Maine Center for Disease
Control and Prevention
An Office of the
Department of Health and Human Services

Subject: Approval for General Use, SeptiTech System

RE: SeptiTech Approval for General Use – Amendment Request

M400 FRALO
INSTALLATION SCHEMATIC

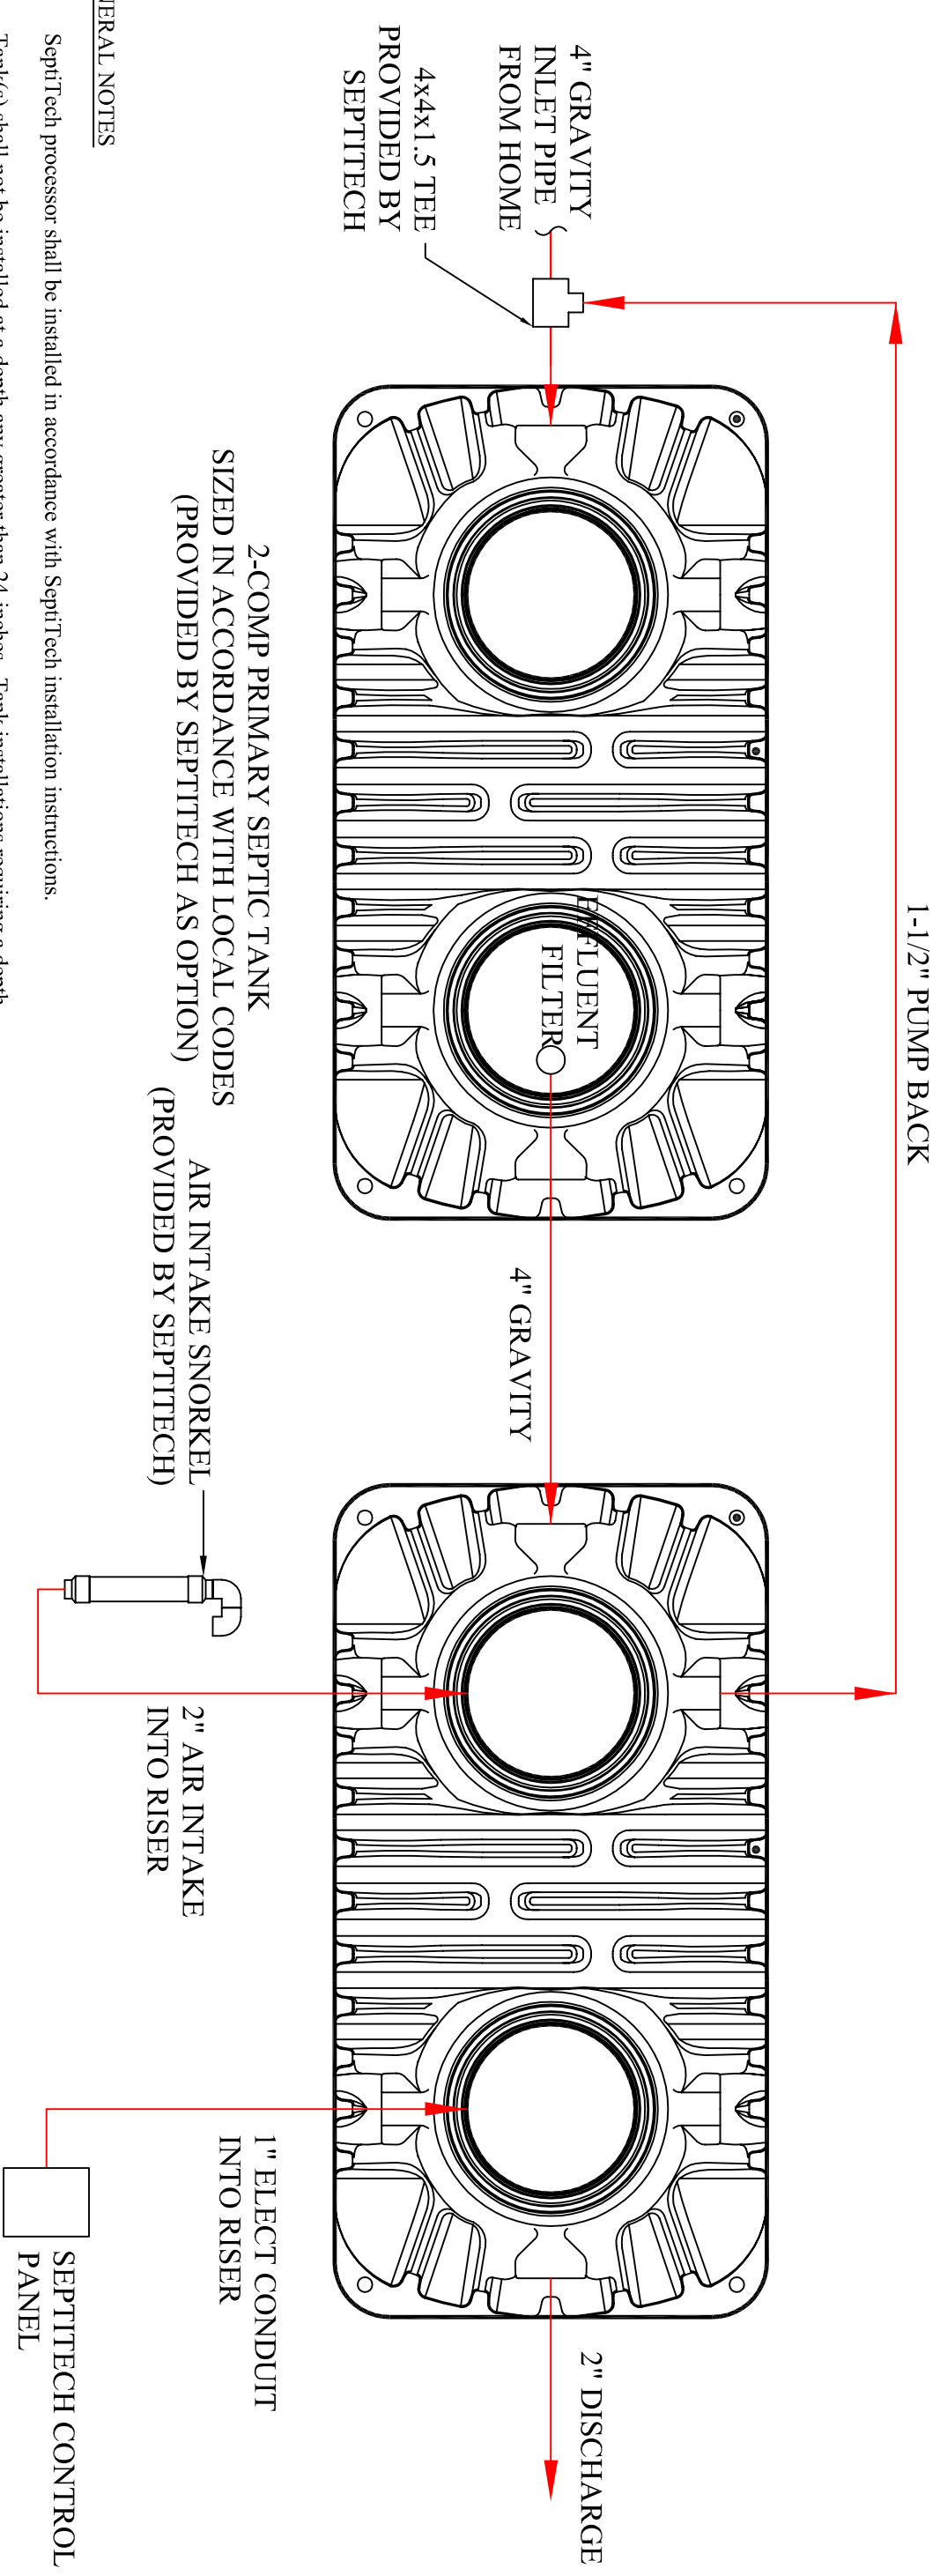
SeptiTech is currently using the FRALO (polyethylene) and Infiltrator (polypropylene) tanks in our system design. Both of these tanks are good tanks but we feel that the GRAF “Carat S” polypropylene tank is of higher quality rigid fabrication, light weight and easier to transport, is resistant to chemicals and organic solvents, and has a larger access opening for inspection and maintenance of our system.

In an email dated August 29, 2013, I had provided you with several certificates and literature on the GRAF “Carat S” tank. I had also provided you with current SeptiTech System drawings using the FRALO and Infiltrator tanks.

The Division approves the use of GRAF "Carat S" polypropylene tanks in SeptiTech systems. All conditions of the approval dated 09/27/12, copy attached, remain in effect.
